STATE OF CONNECTICUT
CONNECTICUT SITING COUNCIL

APPLICATION OF NEW CINGULAR WIRELESS
PCS, LLC (AT&T) FOR A CERTIFICATE OF
ENVIRONMENTAL COMPATIBILITY AND
PUBLIC NEED FOR THE CONSTRUCTION,
MAINTENANCE AND OPERATION OF A
TELECOMMUNICATIONS TOWER FACILITY
LOCATED AT 95 BALANCE ROCK ROAD IN THE
TOWN OF HARTLAND, CONNECTICUT

DOCKET NO. 408

**NEW CINGULAR WIRELESS PCS, LLC ("AT&T")
RESPONSES TO SITING COUNCIL INTERROGATORIES (SET THREE)**

EXHIBIT A

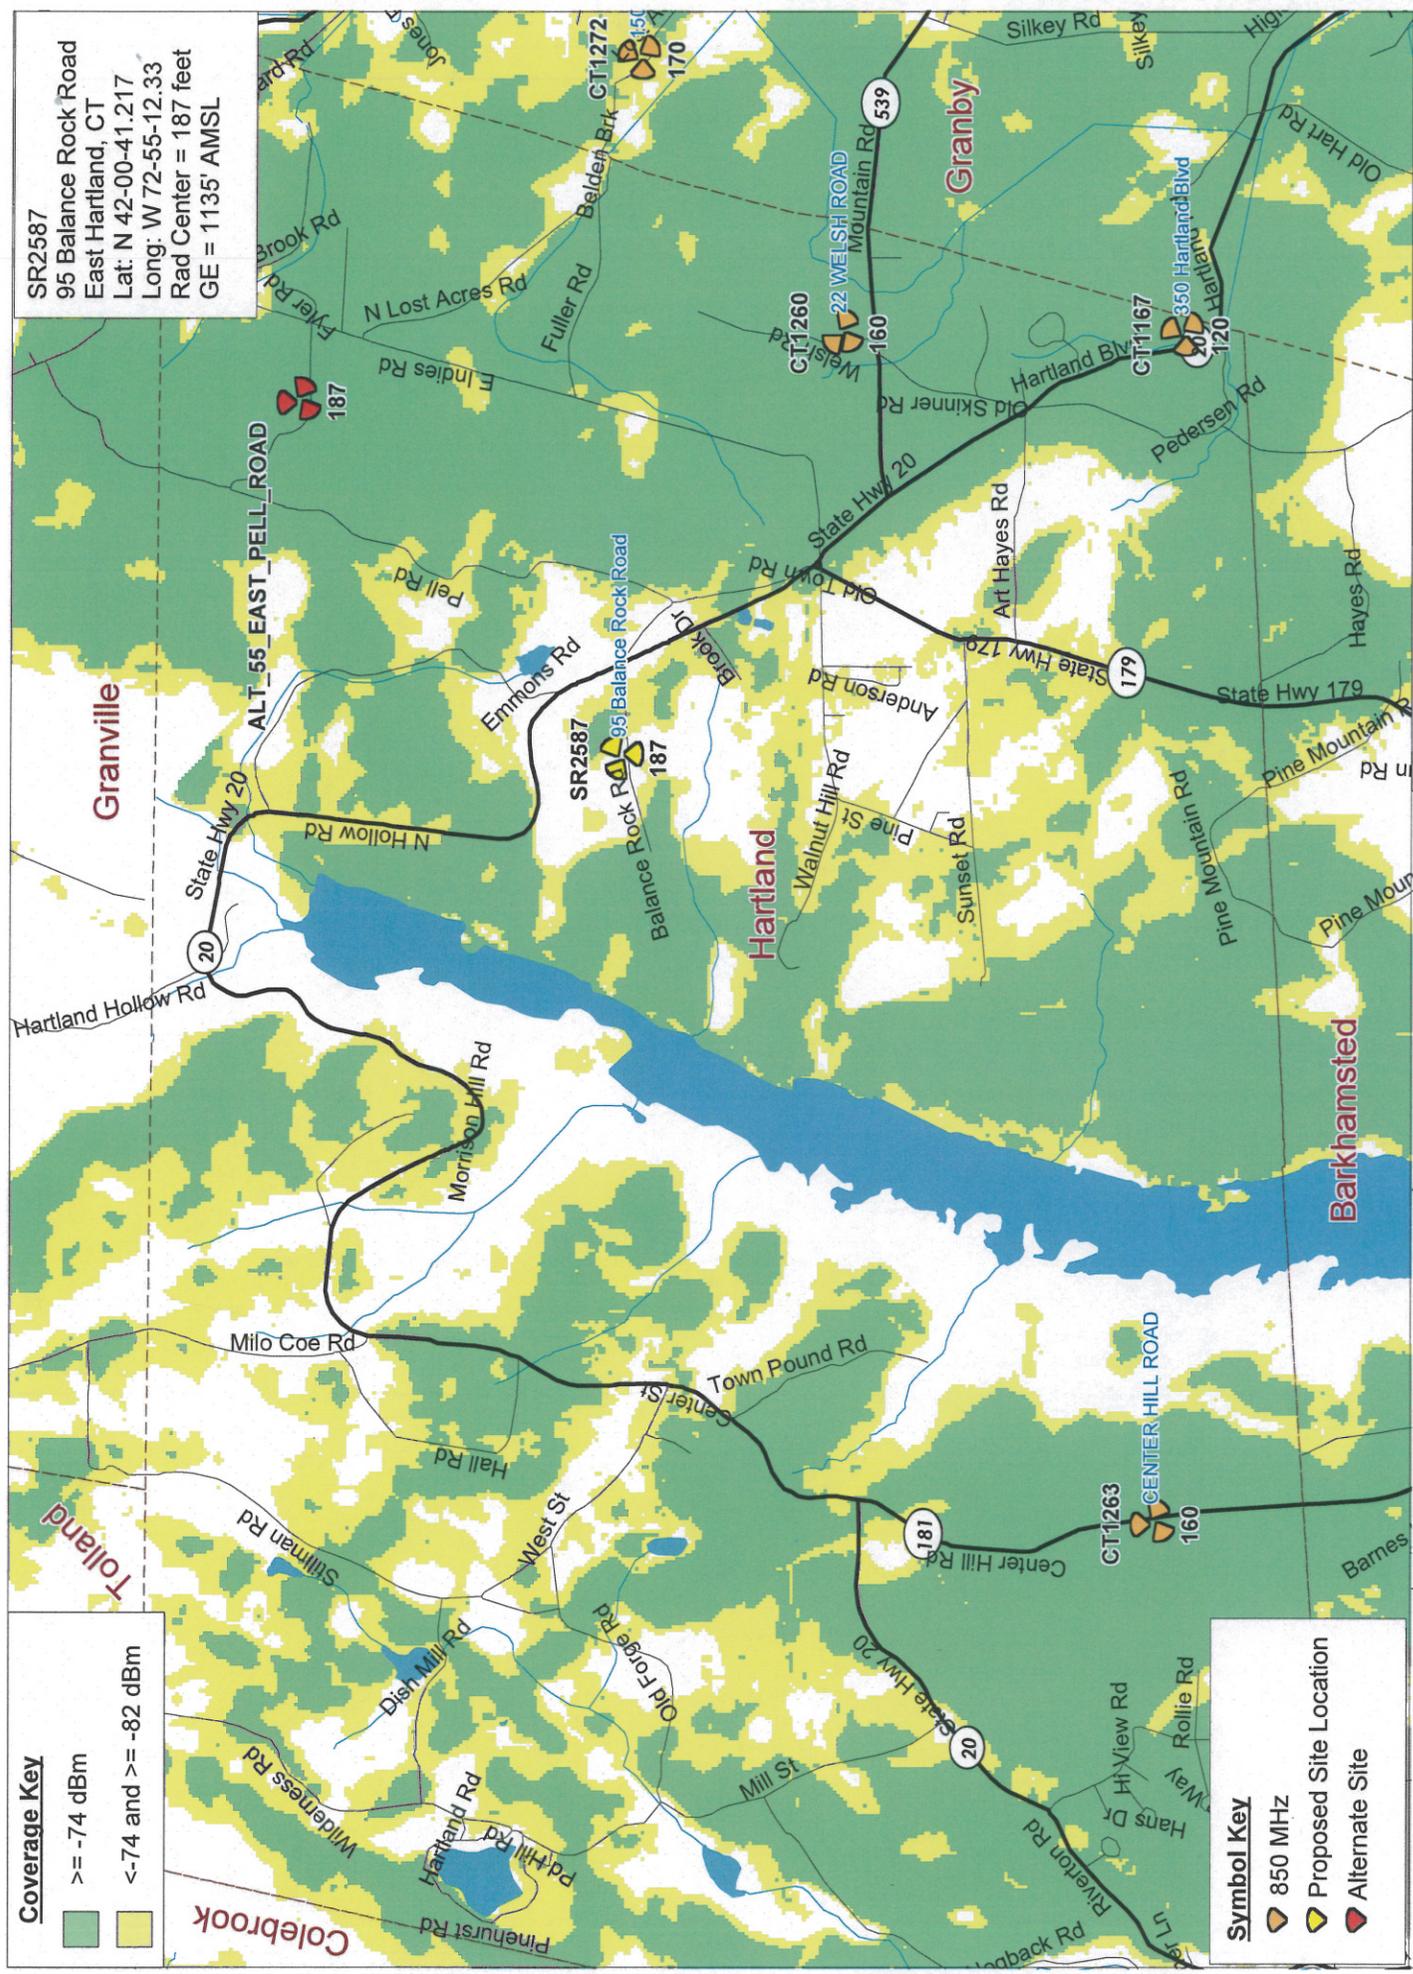
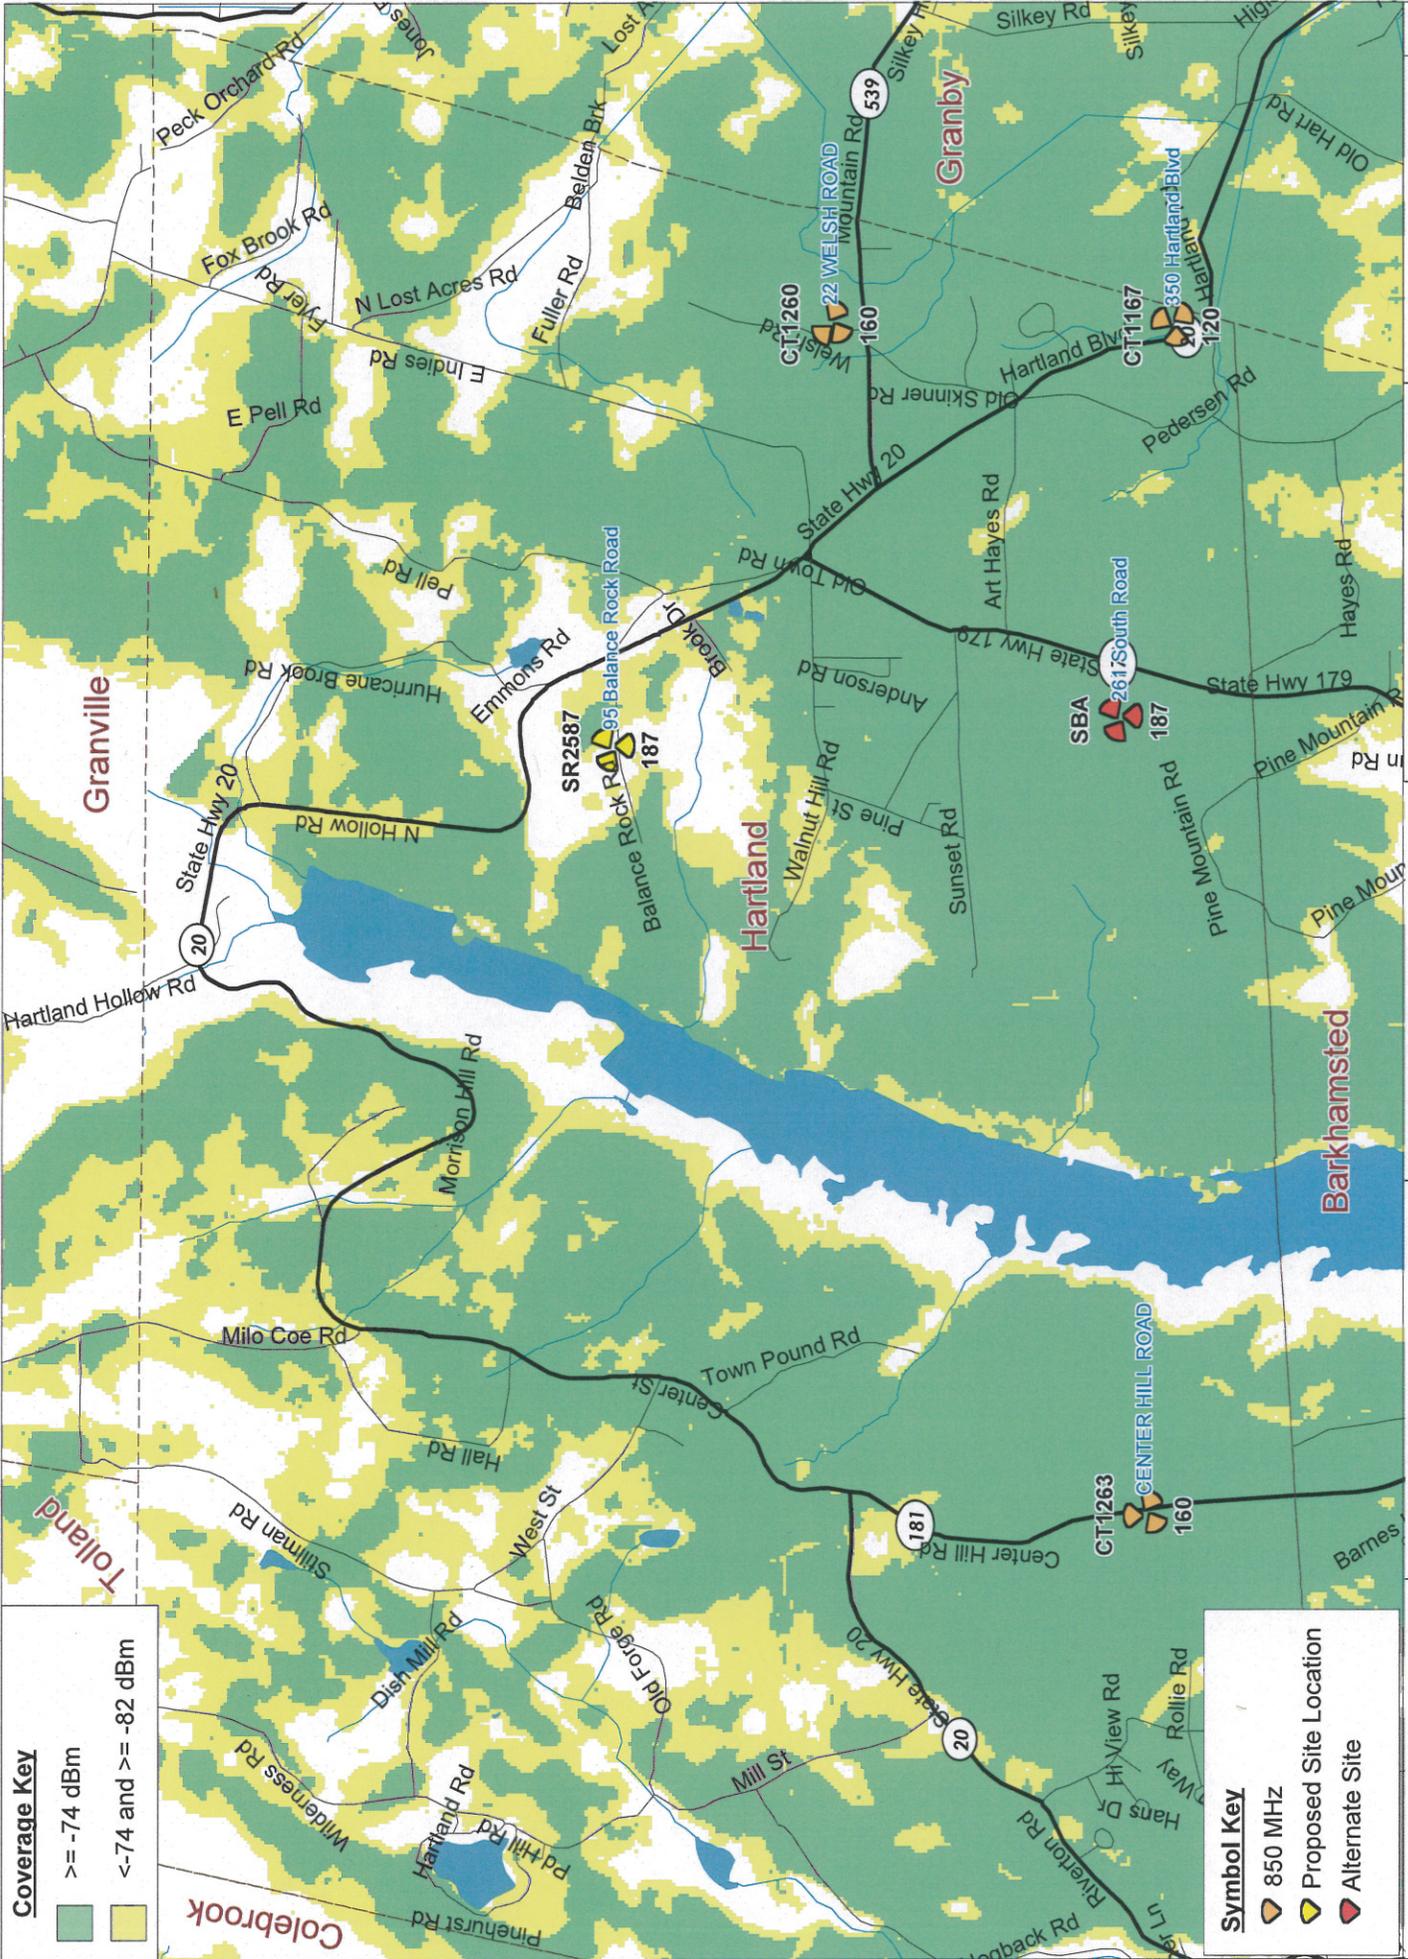
- Q2. Regarding the response to Q. 6 in Mr. Vivian's pre-filed testimony, please provide the propagation plot at the height examined for the property at 55 Pell Road.

- A2. Attached hereto in Exhibit A is a propagation map depicting potential coverage from a tower at the 55 Pell Road property. A height of 190' AGL was analyzed. As demonstrated on the enclosed propagation map, a facility at this location would not provide adequate and reliable service to the area of need in this application.
